STAFF REPORT

Town of Nags Head

Subject: Site Plan Amendment for Inn at Whalebone, 87-unit Hotel located at 6632 W. Pheasant Avenue (W. Lakeside Street).

06001.00 - THE INN AT WHALEBONE, LLC - TRAFFIC IMPROVEMENTS FOR W. LAKESIDE ST.

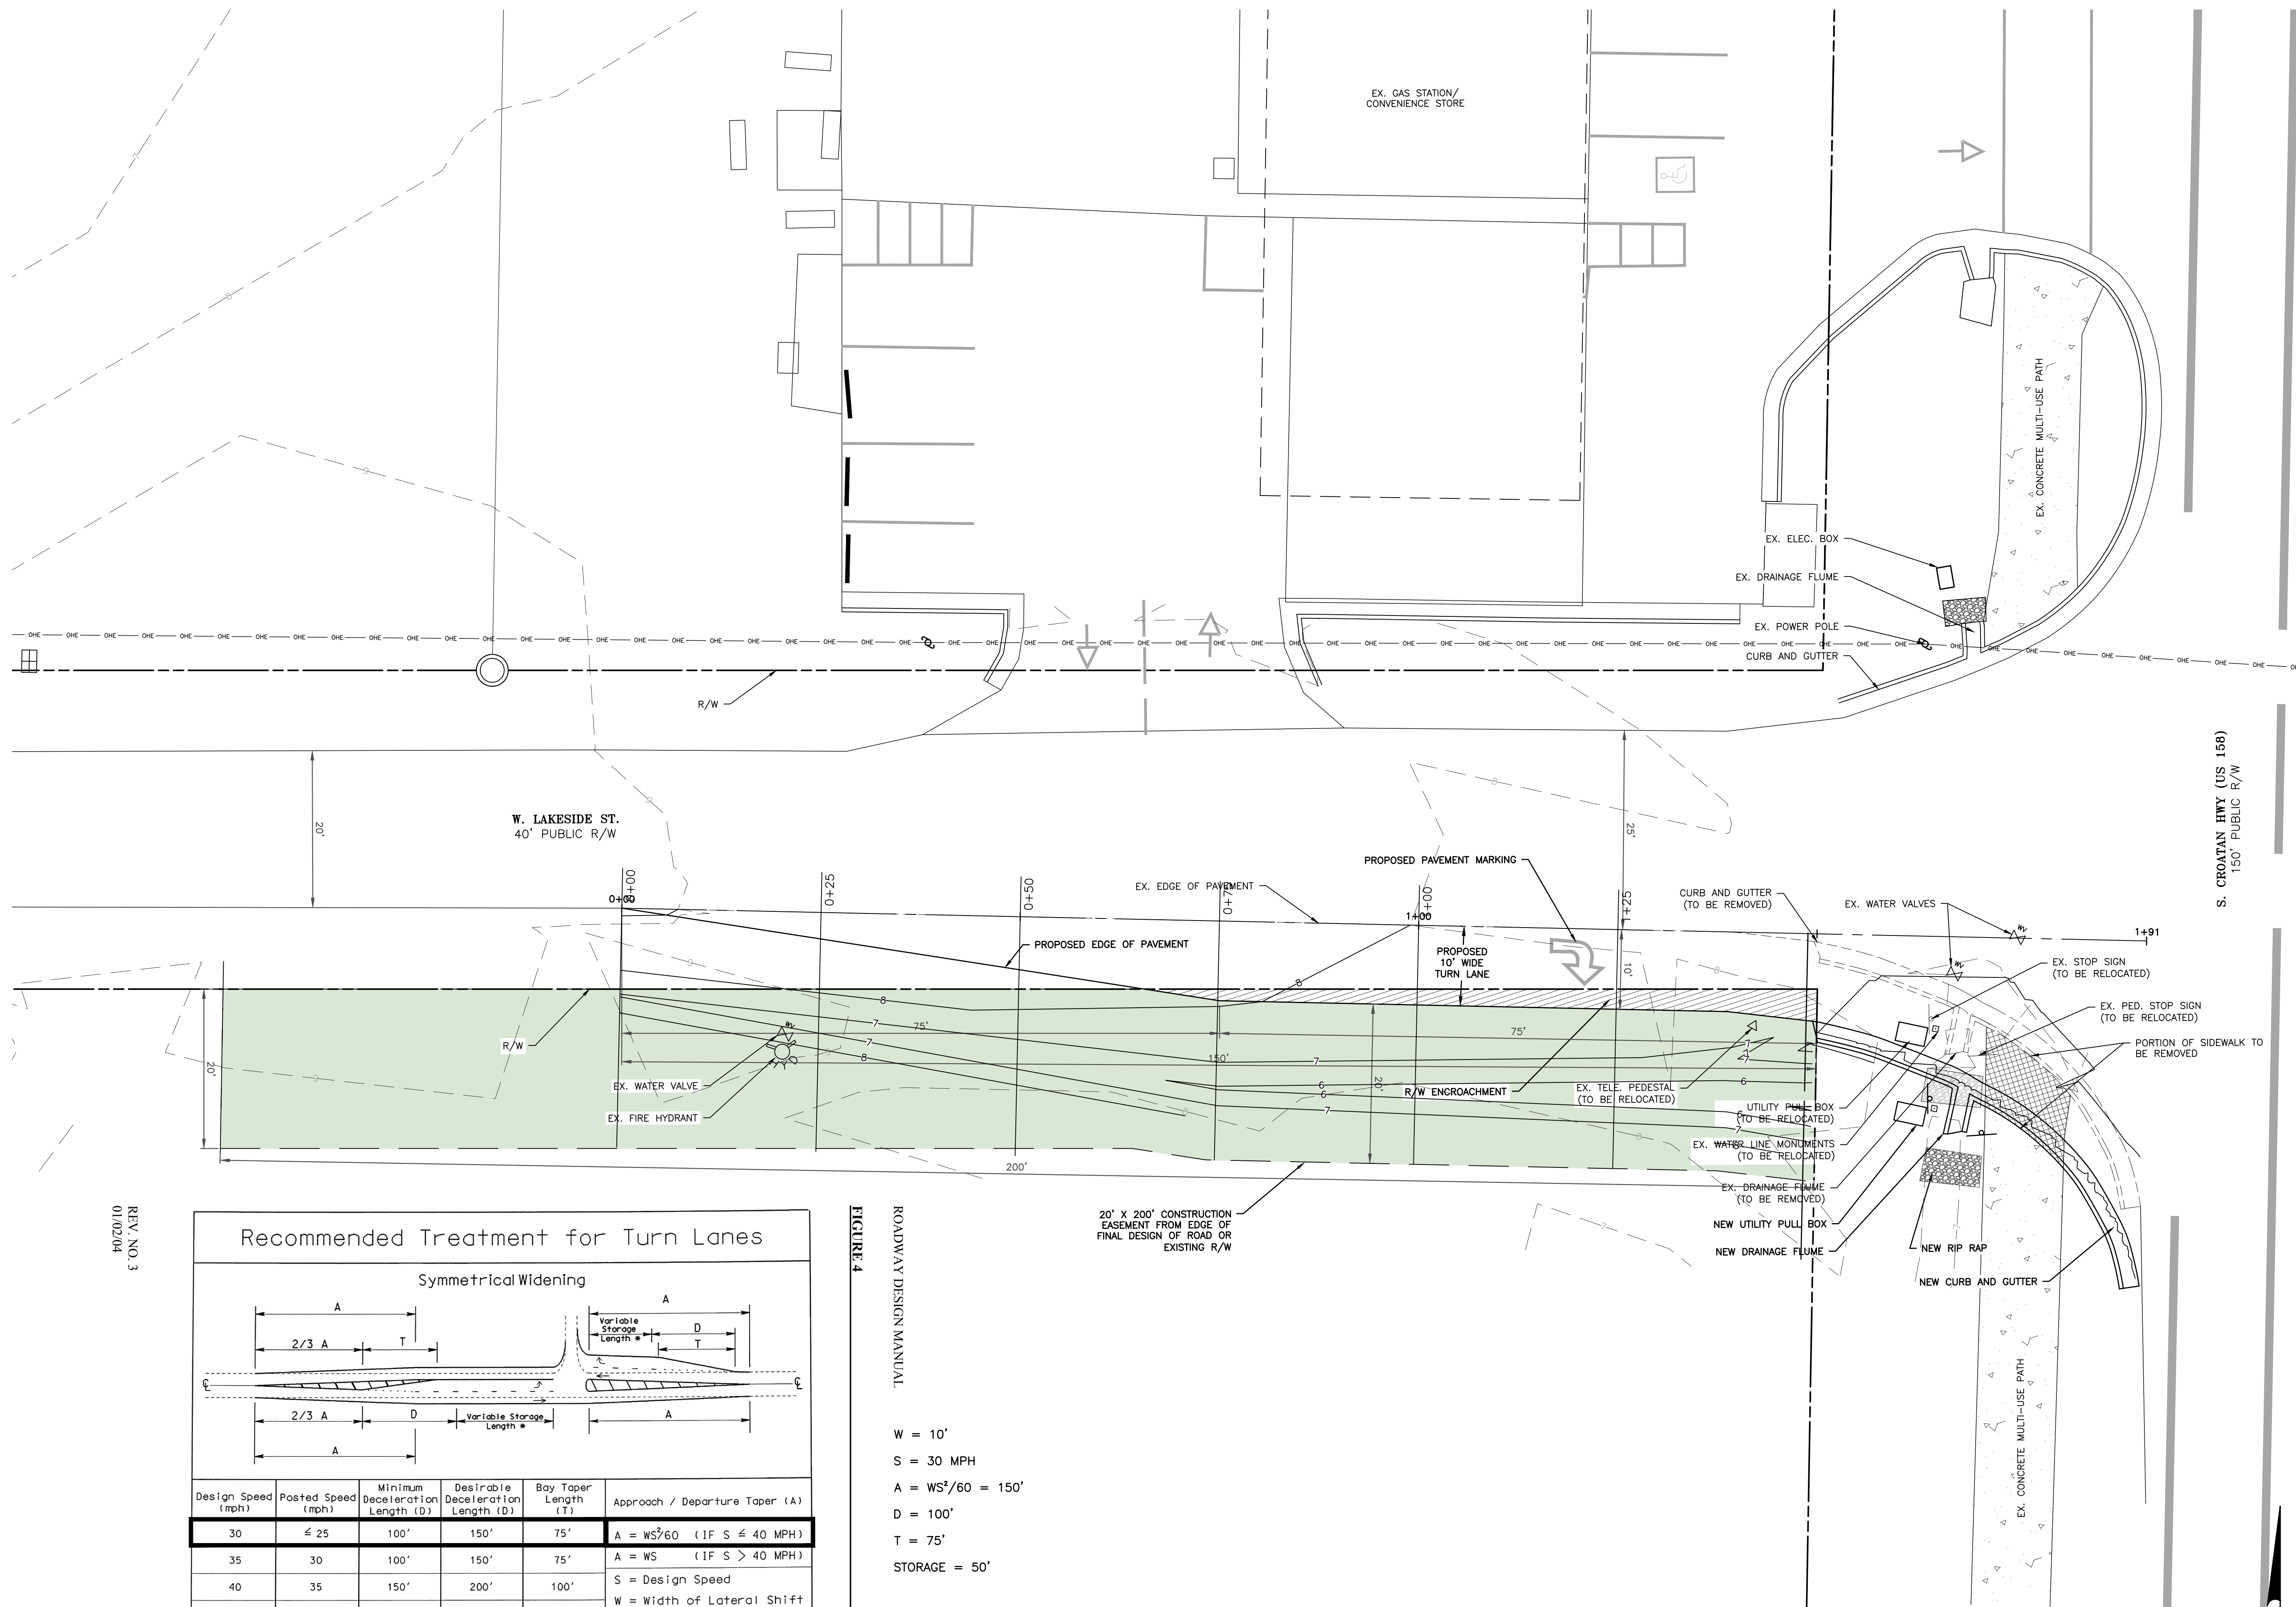
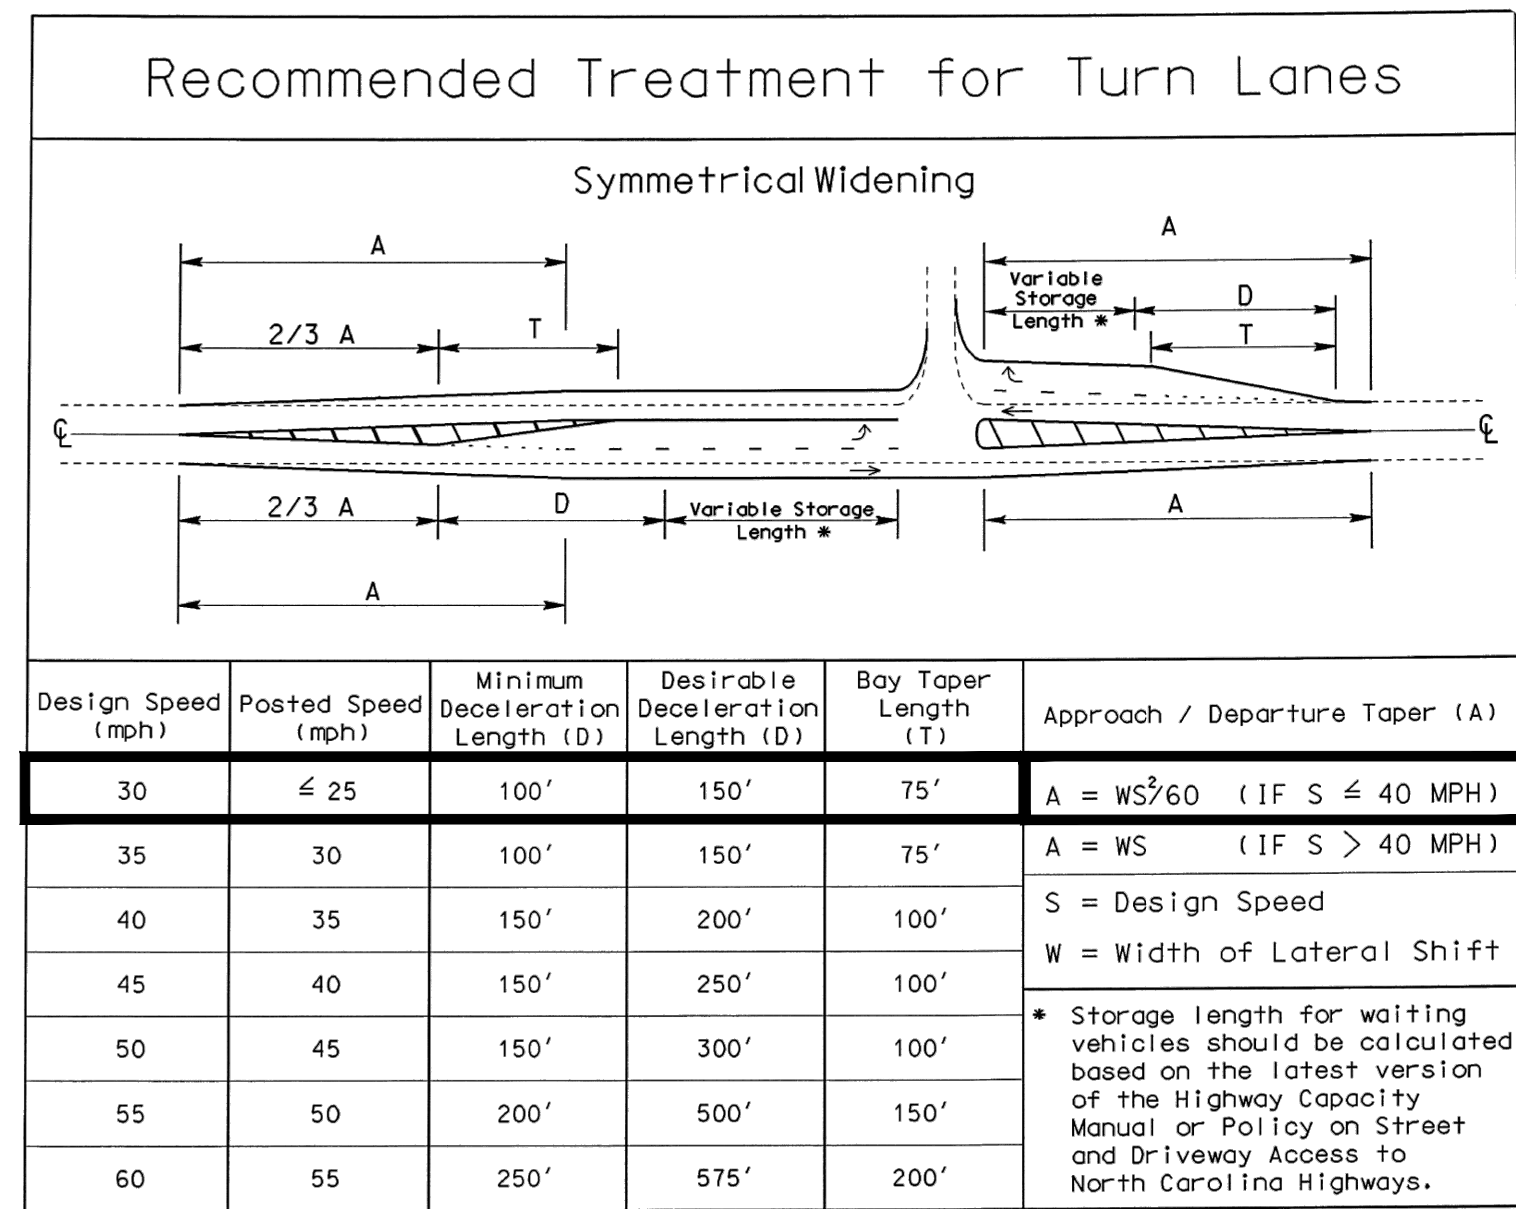
MacConnell & Associates, P.C. has provided a Technical Memorandum outlining the impacts and challenges associated with this request. MacConnell & Associates, P.C. provided a Turn Lane Exhibit for town staff and Board consideration, it is attached for the Planning Board's review. Town Engineer, David Ryan has conducted a review of this proposed exhibit and has provided the following comments:

TURN LANE EXHIBIT

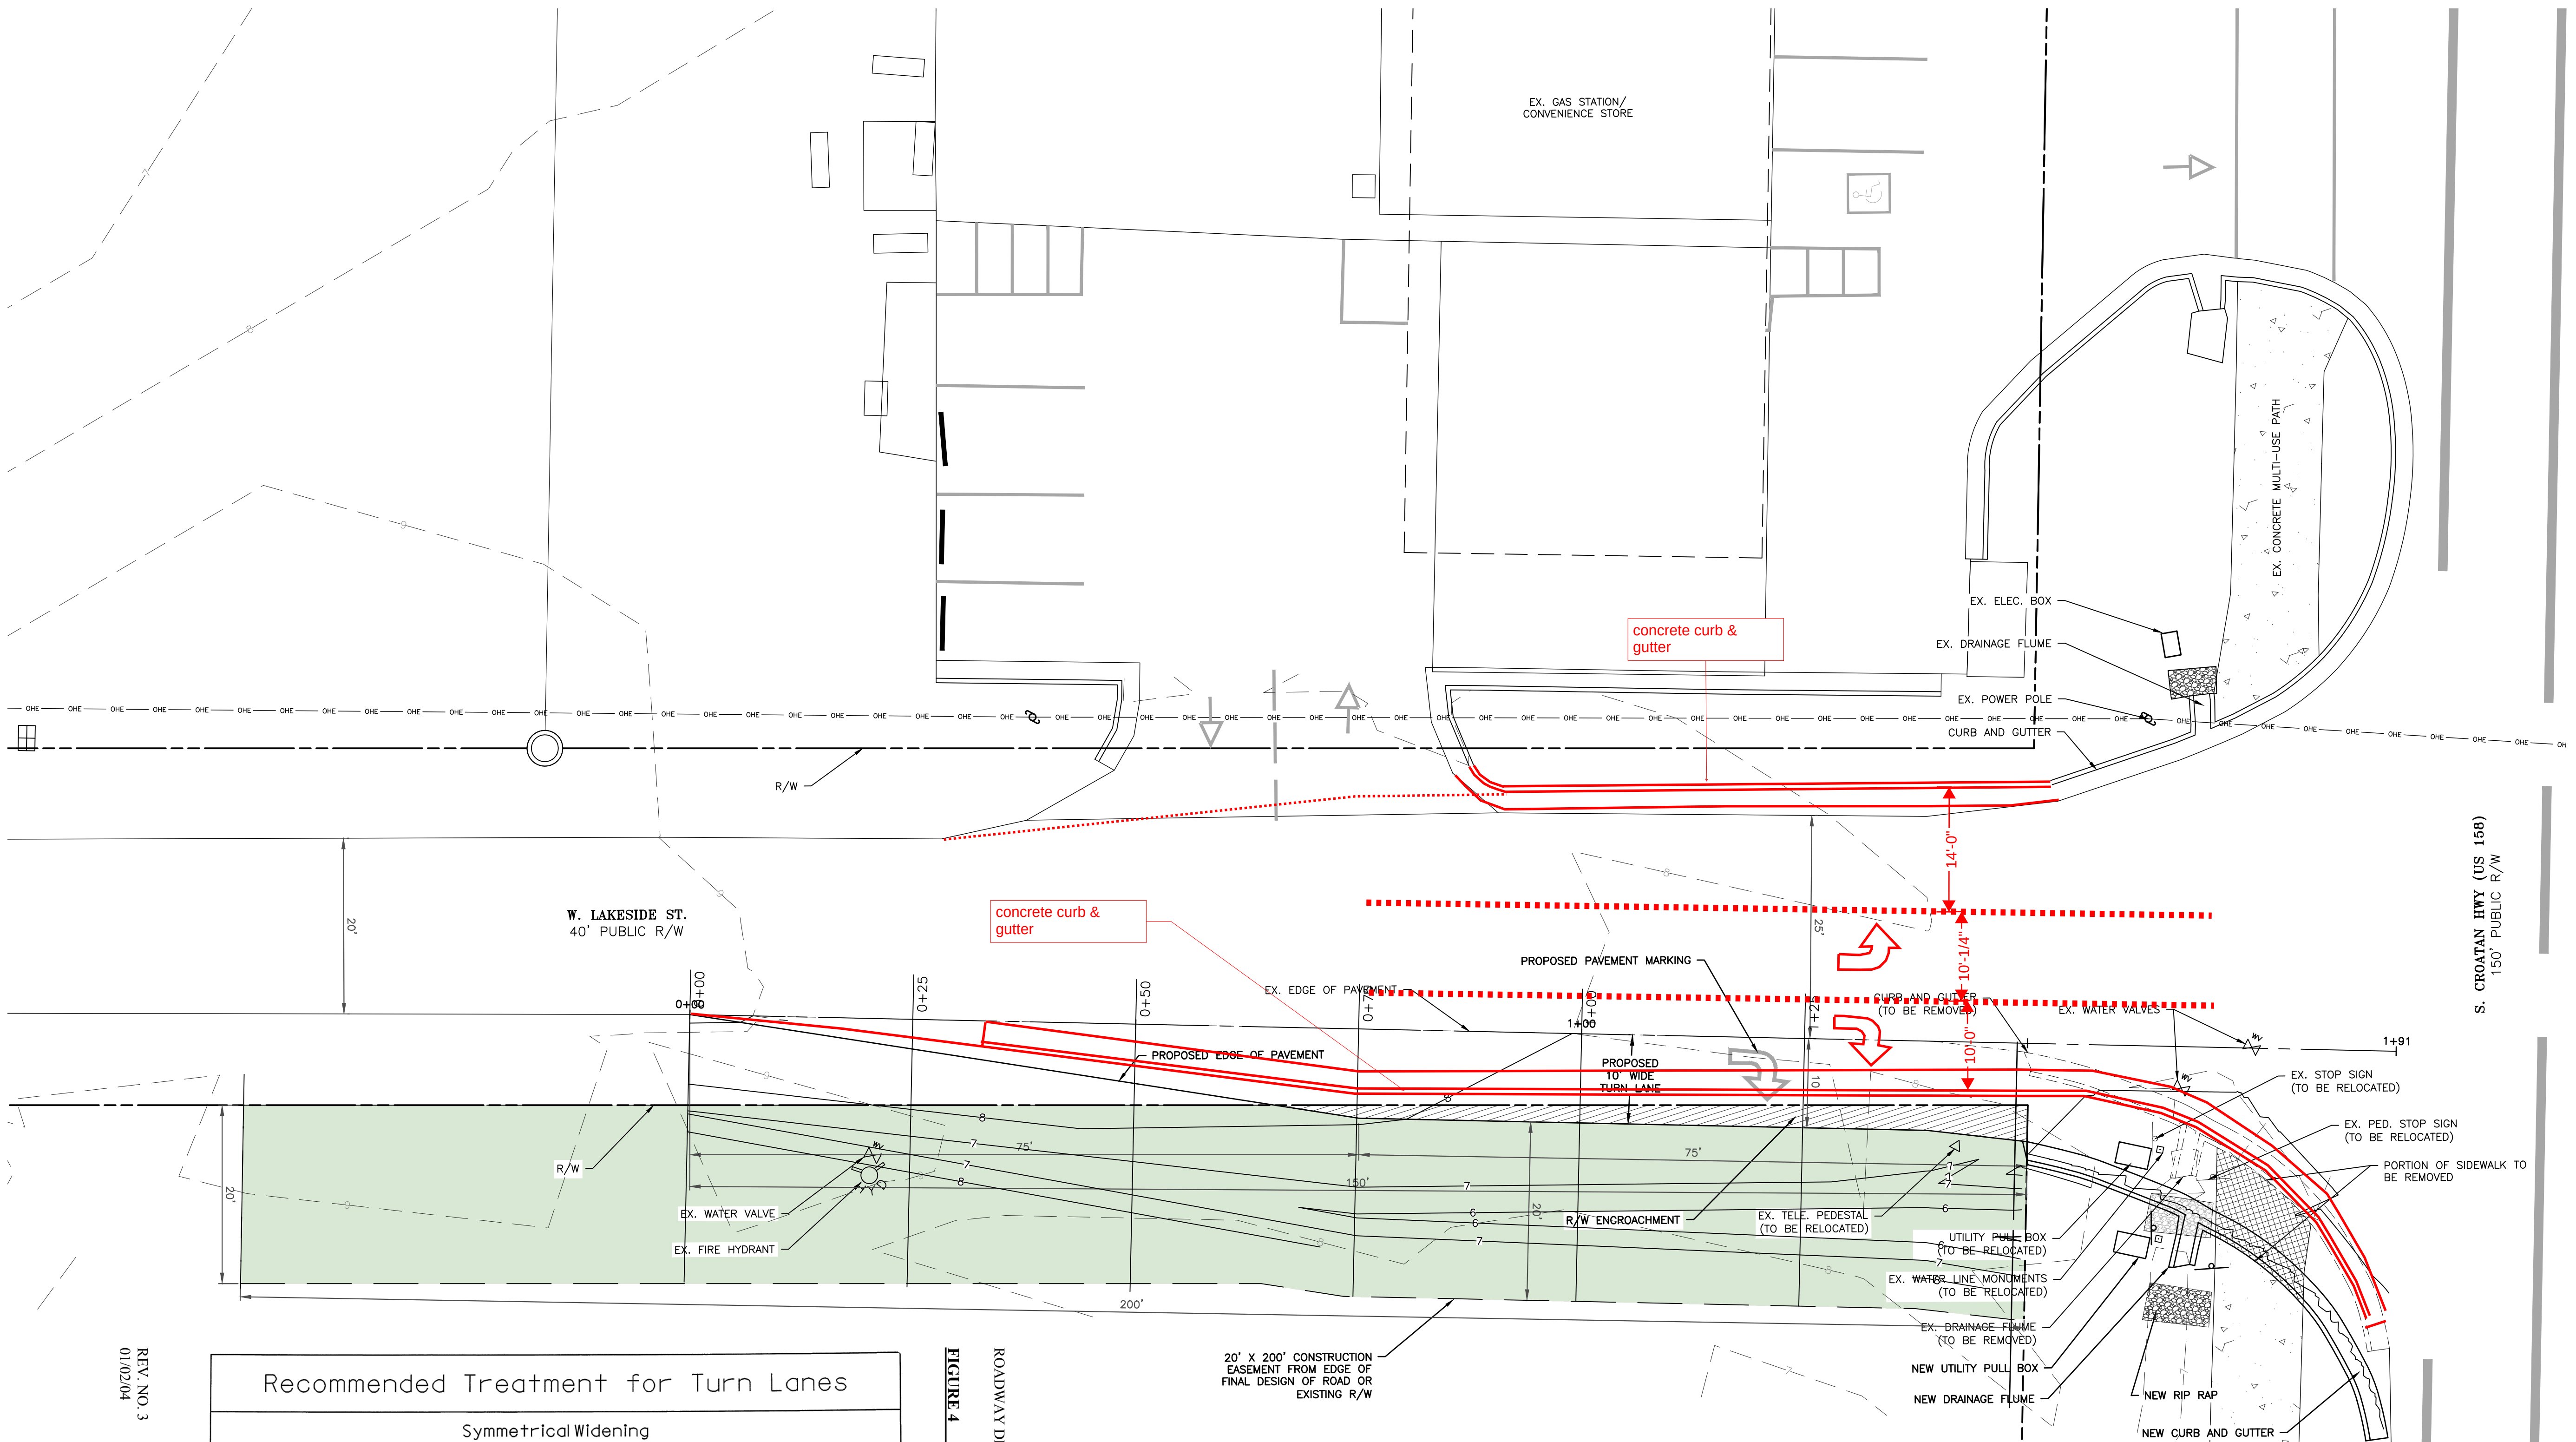
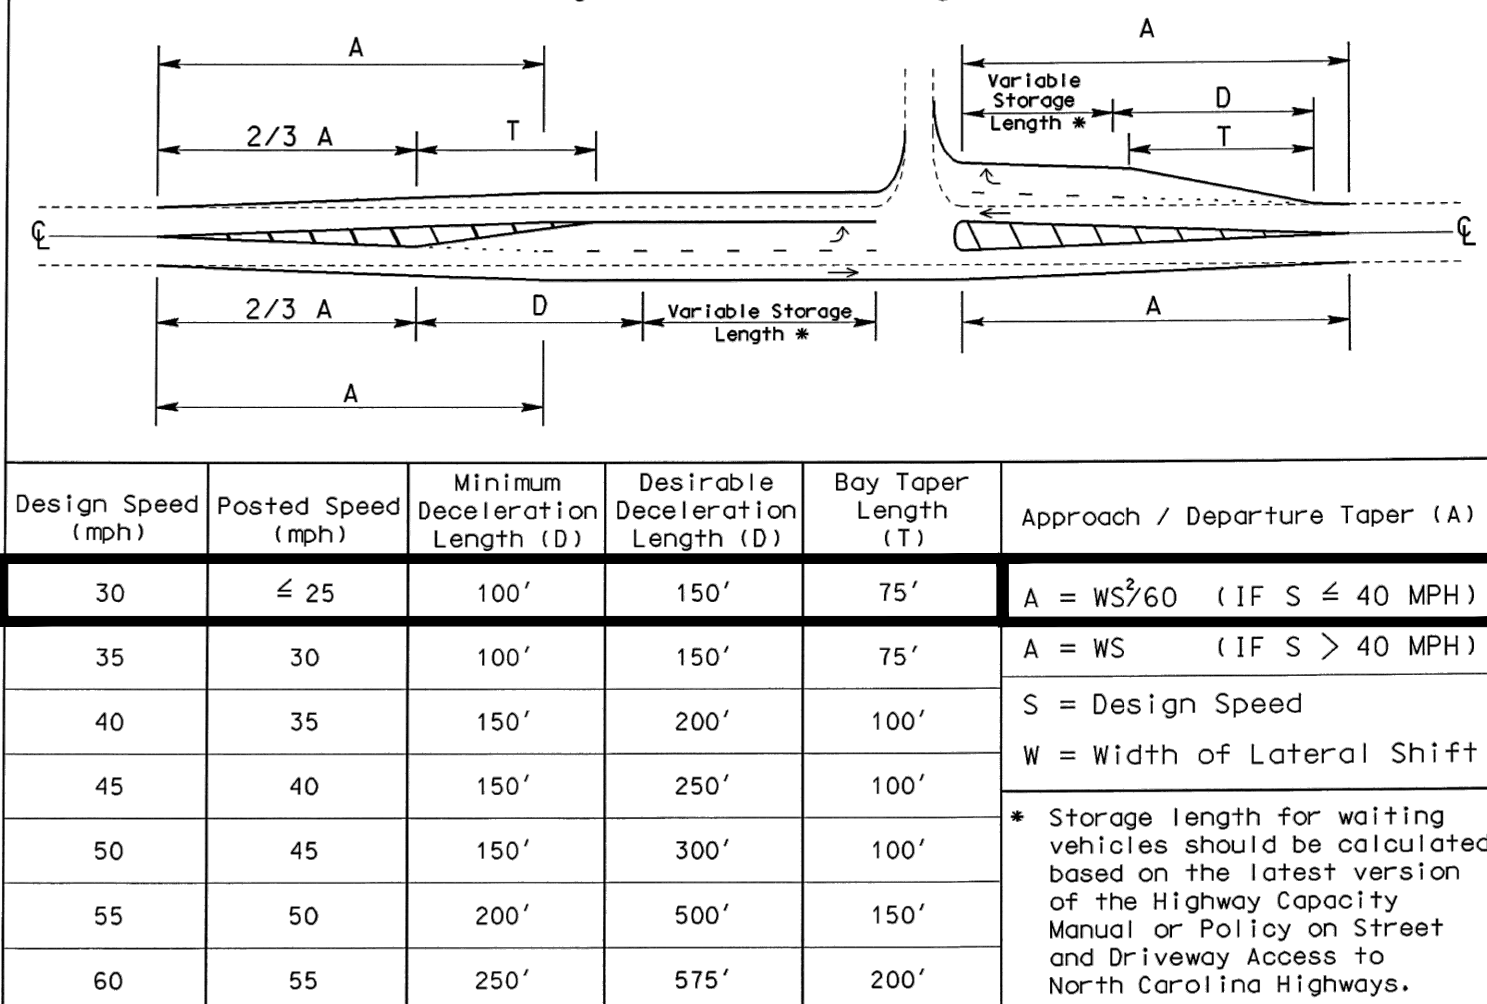
“Lakeside Street Turn Lane Exhibit- A condition was placed on the previous site plan approval to widen the Lakeside St roadway extending from S. Croatan Hwy. to the westernmost boundary of the subject property. With the existing Lakeside St. right-of-way width at 40’ there are some impacts associated with a roadway widening of this length. These impacts include runoff onto adjoining properties and potential conflicts with above ground utilities. However, there is still an opportunity to provide roadway widening to meet the intent of the previous Board of Commissioners conditioned approval.

The applicant has submitted an exhibit which shows a reduced widening plan from the eastern property boundary. This concept indicates an encroachment onto the adjoining undeveloped property to the south. Attached is an exhibit mark-up which describes a potential alternative roadway widening approach which may not result in improvements extending onto private property. The recommendation is for the applicant to modify the traffic improvements for Lakeside St. to reflect the approach as identified in the attached plan mark-up. This approval would be conditioned on the applicant acquiring detailed survey information for the development of a roadway widening and construction plan in accordance with Chapter 36-4 of the Town Code of Ordinances. It should be noted that a temporary construction easement may be required from the owner of the undeveloped property to the south for the purposes of construction in addition to a right-of-way encroachment through NCDOT.”

Regarding the applicant's request to remove or modify the condition to widen Lakeside Street, this condition was included in the October 4, 2023, Board of Commissioners (BOC) approval to address traffic concerns raised by citizens and Board members. While fully meeting this condition could impact runoff onto adjacent properties and conflict with above-ground utilities, there is an opportunity to widen a portion of the roadway. This approach would fulfill the intent of the Board of Commissioners' conditioned approval without encroaching on adjoining properties. Staff recommends that the Board of Commissioners consider modifying the approval to reflect the alternative roadway design proposed by the Town Engineer.
